Brooklyn Inland Wetlands Commission
Special Meeting Agenda
Tuesday, September 12, 2023
Zoom and In-Person Meeting
Community Center
31 Tiffany Street Upper Level
6:00 p.m.

1. IWWC 23-006 Ryan Kelleher. 404 Wolf Den Road, Map 18, Lot 22, RA Zone;
Improvement of an existing gravel driveway through a wetland to construct a single-family home on 41 acres of land.

In response to review comments from Regional Engineer, Syl Pauley, P.E. on the referenced project, we offer the following:

The comments contained herein pertain to my review of plans and supporting documentation, which is for the construction of a driveway across a wetland. The plans consisting of three (3) sheets were created by Killingly Engineering Associates, dated May 24, 2023 with revision date of July 31, 2023.

DRIVEWAY BOX CULVERT SECTION

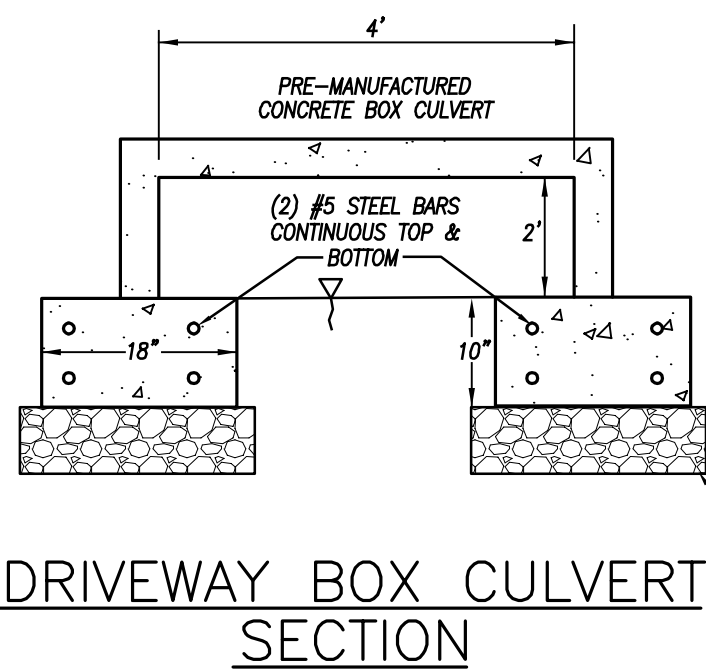
1. Inverts (in – out) for each box culvert need to be added to the "Driveway Box Culvert Detail."
2. The dimensions of the "Driveway Box Culvert Section" do not match the area (interior 4'x2') used to calculate flow in the Drainage Calculations. Which is correct?

The dimensions on the "Driveway Box Culvert" detail have been modified to shown interior dimensions of 4'x2'.

Wetlands filled but not shown on either as-built plan. Photo 19 taken from the last pipe (westernmost) under the driveway, facing southwest.

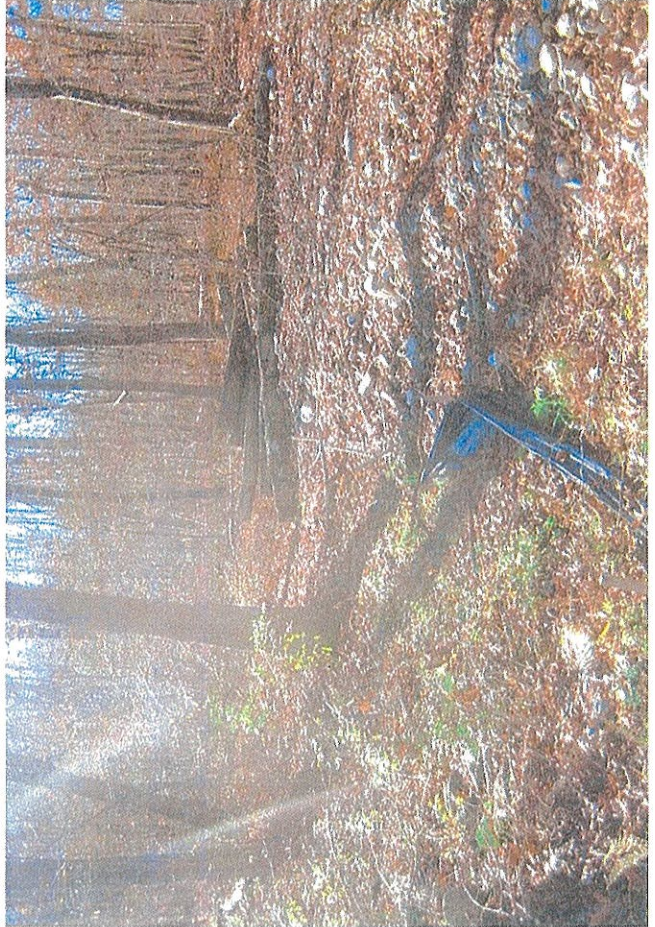
The wetlands filled southwest of the last pipe under the driveway should not have been filled. This filling was not shown on the approved driveway plan. There is only 9" of fill over the third (westernmost) pipe in the middle crossing.
